RE: Planning Application 01/01151/FUL 47-55 Westwood Road.

It was stated in the previous letter that it had been brought to our attention that Plot 1 of the above development had been constructed with a window at the second floor level in the southern (side) elevation. The window does not appear on the approved plans, namely ARK/WEST/003 and ARK/WEST/002 as defined in the decision notice.

47 – 55 Westwood Road, Tilehurst – Planning Permission No. 01/01551/FUL
Re: Method Statements for Remedial Works to Plot 5 and Removal of BT Duct

776 – 103A

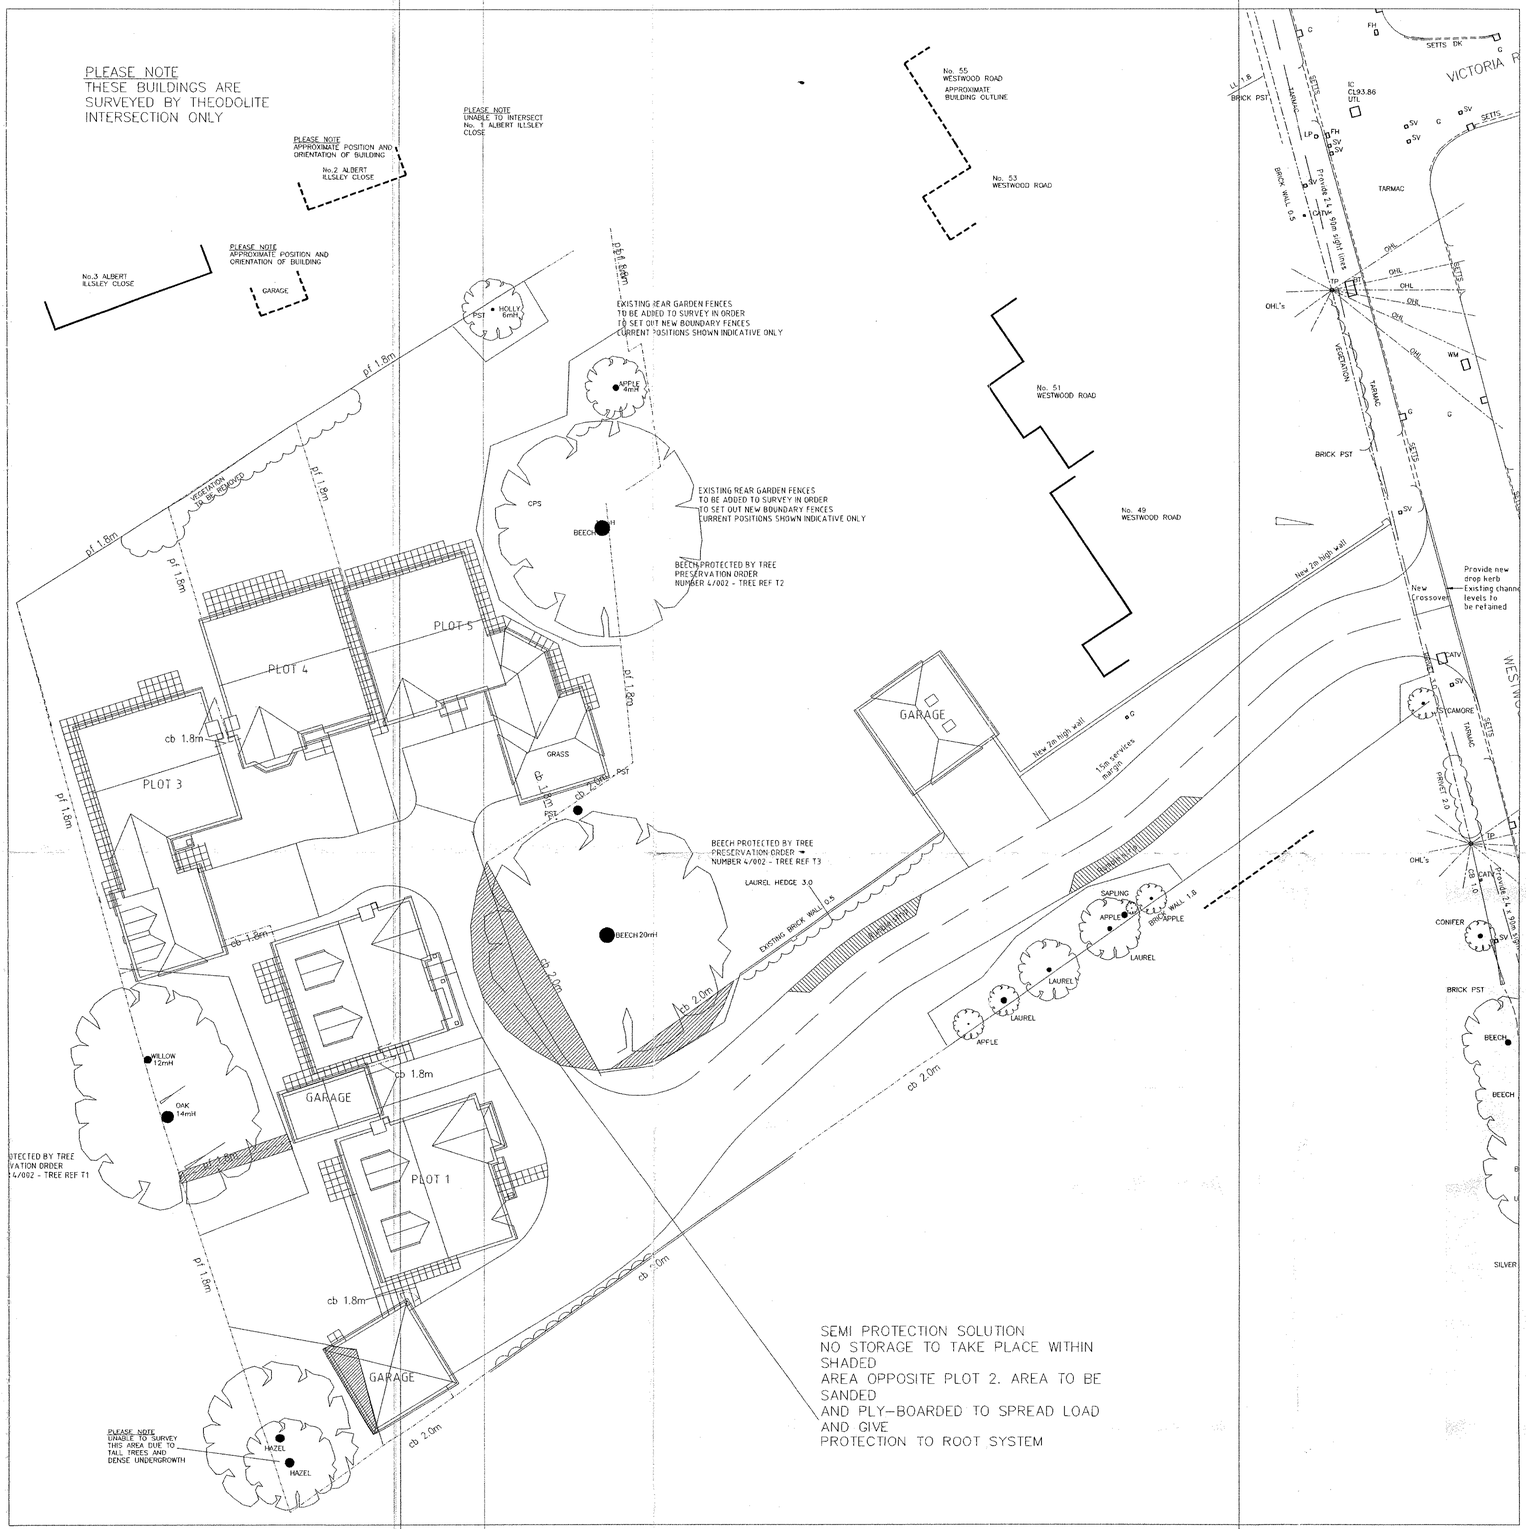
14	The tree protection as shown on the approved Tree Protection plan, as required by Condition 13 above, shall be erected around all retained trees before any equipment, machinery or materials are brought onto the site for the purposes of development, including demolition, and before any other works are started. The tree protection shall be retained throughout the entire period of construction and until all machinery and surplus materials have been removed from the site. High visibility tapes bearing the inscription "Tree Retention Area Keep Out" should identify such protection areas.	Tree Protection Erected	CH can confirm tree protection erected on site as per plan 103 rev A. Is this acceptable?
15	No construction processes are to occur within the minimum protective distances to as required by Condition 13 above, without the prior written consent of the Local Planning Authority.	N	Details submitted by Bewlet 22/11/02 re: back filling of trenches incorrectly dug for plot 5 on 776-102 rev A - are these acceptable?
